Product information

Item affected / Type	Coin cell Holder type NL5077-LF, NH5077-LF, NL5077-LFRS		
Part - Nr. (SAP)	701111, 701212, 704045	PCN No.	KAS-210920

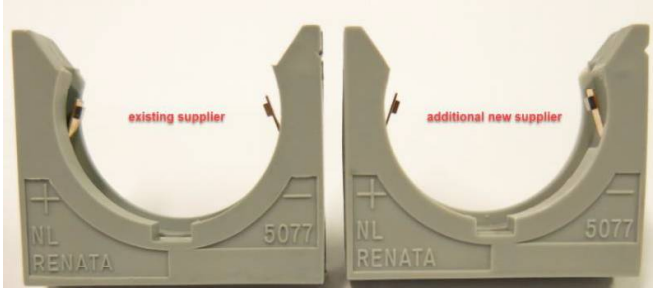
Product Change Notification	Description and reason of change
	With a recent shortage of raw material in the market, Renata is planning to use a 2 nd supplier for raw material of holder Body in order to minimize / eliminate any supply uncertainty.
	Actual material from 1 st supplier: Polyamide 66 Zytel 132F NC010 color grey Material from 2 nd supplier: Polyamide 66 Leona 1300S color grey
	There is no change in Form, Fit and Function.
	Picture example NL5077-LF holder
